**ZONING MAP AMENDMENT
BOONE COUNTY PLANNING COMMISSION**

1. Name of Project: Wendy's Restaurant with Drive-Thru
2. Location of Project: NW Corner of Parcel ID: 074.00-00-077.03 (Project Area: SW Side of Lakeside Dr & Mt Zion Rd Intersection)
3. Total Acreage of Project: 1.2 Acres +/-
4. Current Zoning of Property: MHP (Mobile Home Park)
5. Proposed Zoning of Property (classification being requested): C-4 (Commercial Four) / CD
6. Proposed Use(s) (specify each use):
Proposed is an eating and drinking establishment with drive-thru facilities.
7. Proposed Building Intensities (specify for each building):
Gross floor area is approximately 2,300 SF +/- with space for approximately 40 seats in the dining room.
8. Are you applying for any of the following (check all that apply):
 Conditional Use Permit Variance
9. Current Owner: Mt. Zion MHC LP
 Address: 467 Erlanger Road

ZONE CHANGE/CONCEPT PLAN COMMITTEE REPORT

WENDY'S RESTAURANT CONCEPT
 MT ZION ROAD & LAKESIDE DRIVE
 UNINCORPORATED BOONE COUNTY, KY
 LAYOUT PLAN

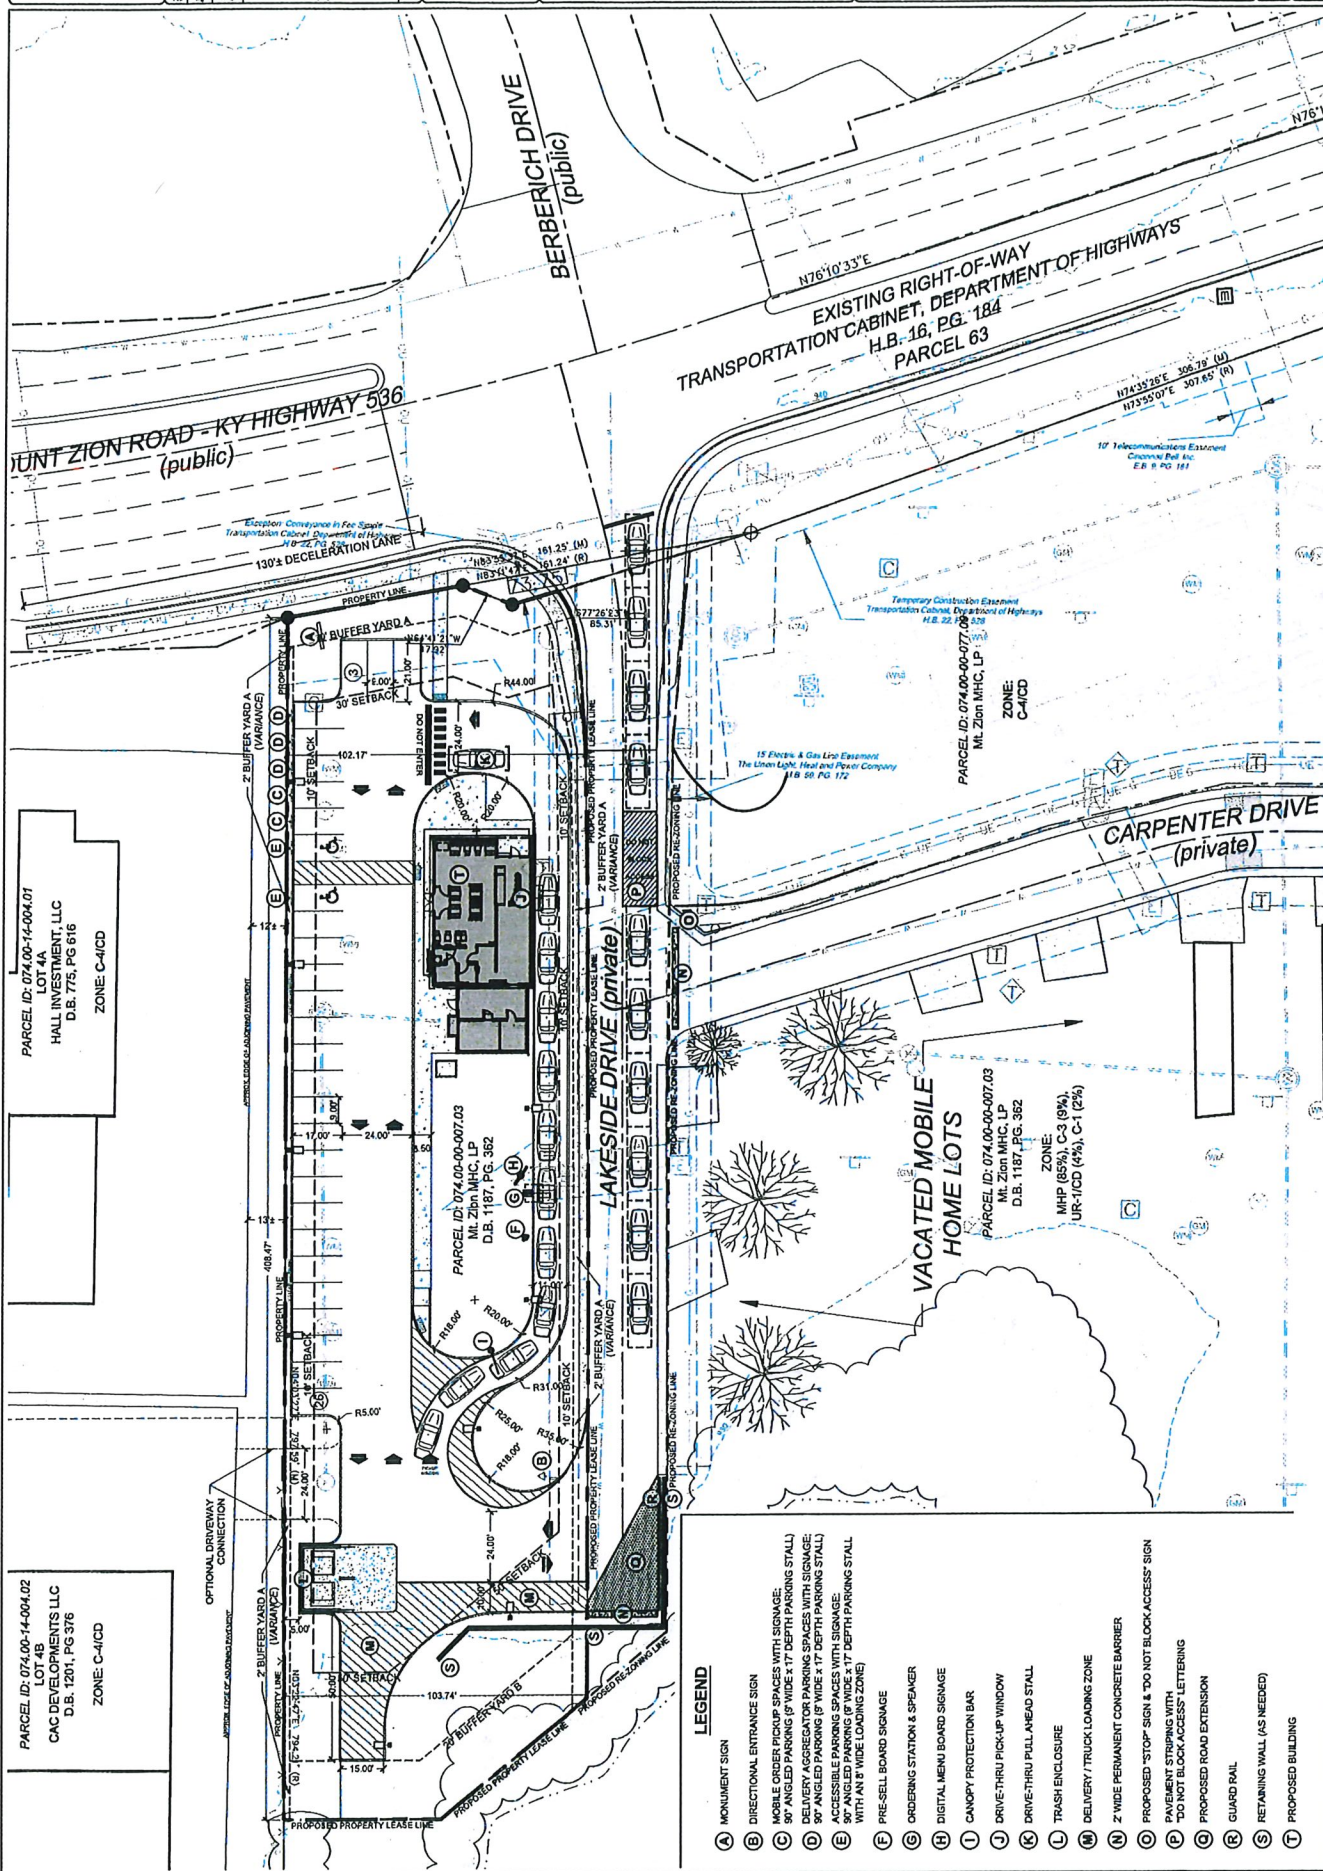
1. The Concept Development Plan for the McDonald's site showed a barrier curb running perpendicular to Lakeside Drive. This curb would be located just past the proposed McDonald's entrance. One of the bases for the approval for McDonald's was that the only traffic on Lakeside Drive would be McDonald's customers. McDonald's was the only leased area and was not connected to adjoining properties. The proposed Wendy's development could create numerous access issues for both sites.

5. The plan shows an optional driveway connection. Has the applicant had discussions with the adjacent owners that would allow for a connection over to Demia Way?

7. With this application, it appears that the redevelopment of the mobile home park is being done in a piecemeal fashion. To provide better coordination, the property owner should develop a plan for the entire property, which could then be developed in phases.
